SAXTON NUCLEAR FACILITY

Operating License No. DPR-4  
Docket No. 50-146  
Technical Specification Change Request No. 55

UNITED STATES OF AMERICA  
NUCLEAR REGULATORY COMMISSION

Figure 1  
Saxton Nuclear Facility Layout

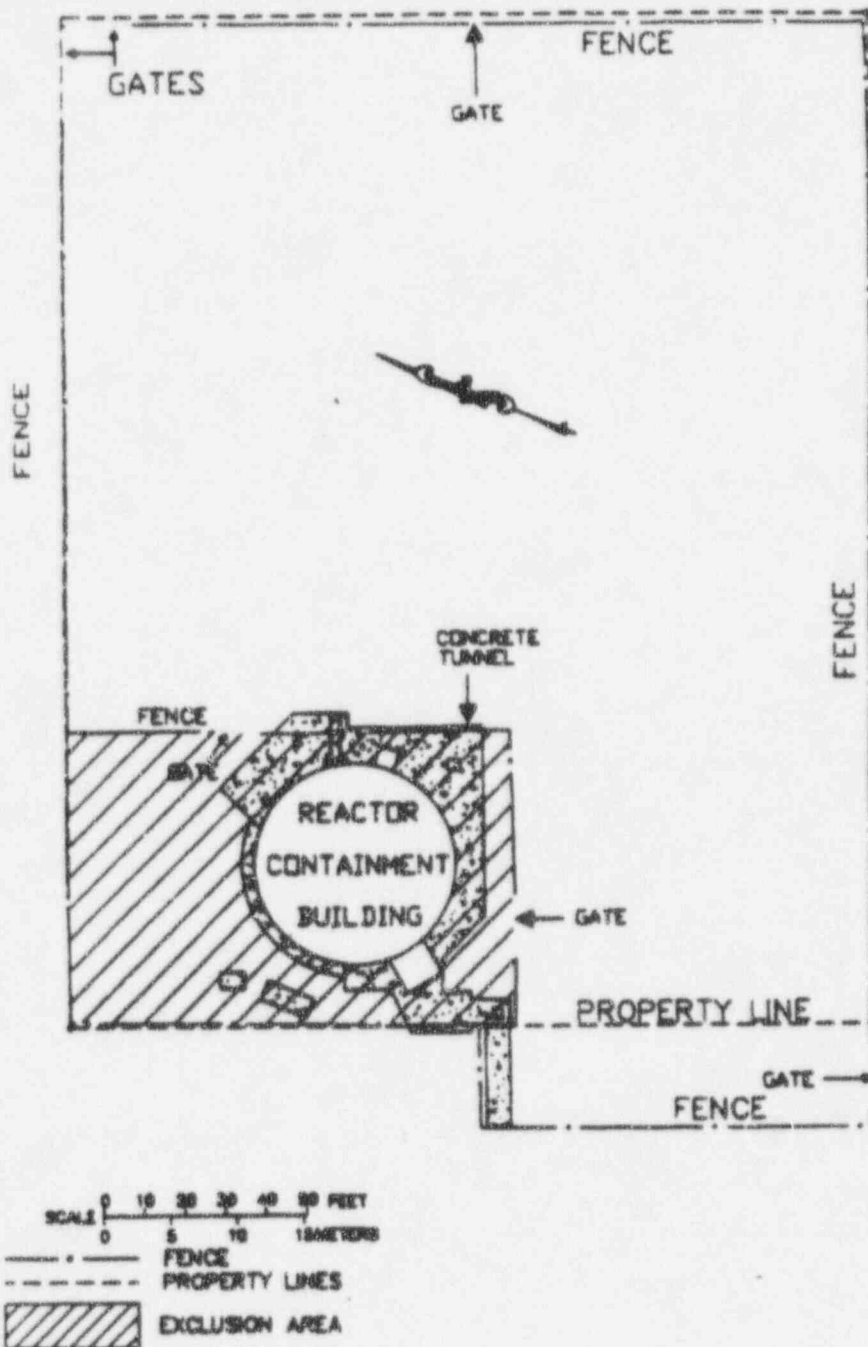
**Question 8** *Figure 1 of your proposed TS is not the figure in your existing TS. Please explain your reasons for changing Figure 1.*

The previous version of the Saxton Nuclear Facility Layout, Figure 1, was a hand drawn figure. The figure was transferred redrawn and maintained as a CAD file. The information provided by the figure has been revised in the following ways:

- 1 the SNEC property line has been included,
- 2 the Containment Vessel Pipe Tunnel is now identified as a Concrete Tunnel,
- 3 the personnel access gate in the east fence which has always existed and was not previously shown. The gate provided access to the Penn Elec line shack from the SNEC site. It has not been used in recent memory and remains locked,
- 4 the remnants of the steam tunnel from the containment building to the Saxton Steam Electric Station are now depicted on the southwest side of the containment building,
- 5 concrete equipment pads located on the west side of the containment building are now depicted,
- 6 the labels for the personnel access, emergency access and equipment access doors have been eliminated.

Figure 2

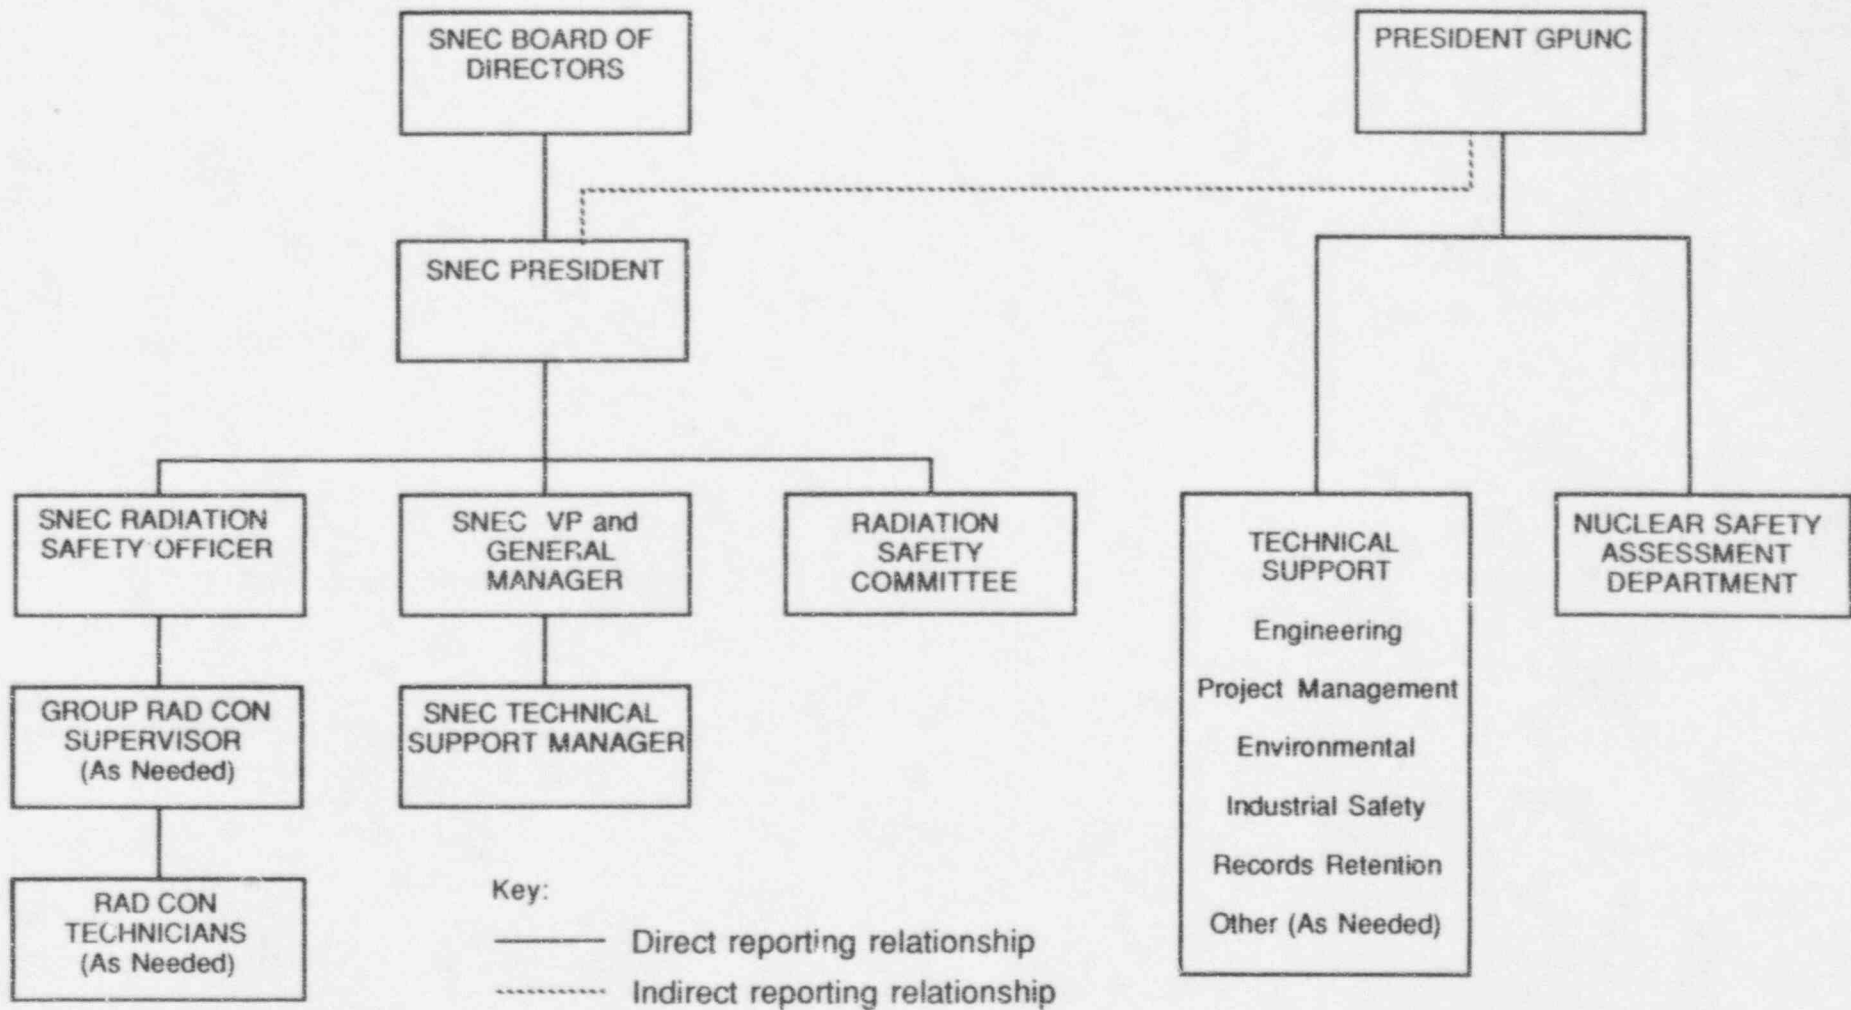
**Question 3** *Your proposed TS B.1.b discusses the SNEC Technical Support Project Team. Is this the box in Figure 2 labeled Technical Support under the President GPUNC? Your request of August 8, 1994, showed SNEC Technical Support under the SNEC President. Please explain and clarify this issue.*

The box in Figure 2 labeled Technical Support under the President GPUNC is the portion of the organization discussed in TS B.1.b. The figure included in the request of August 8, 1994 depicted the SNEC organization prior to the evaluation of the contribution of Technical Functions (TF) Division personnel to the effort. In the interim between the submittal

and the response to the request for additional information, work previously considered for contractors was allocated to GPUN and the figure was revised. Figure 2 now identifies the project nature of the efforts of technical groups within GPUN working in support of SNEC decommissioning.
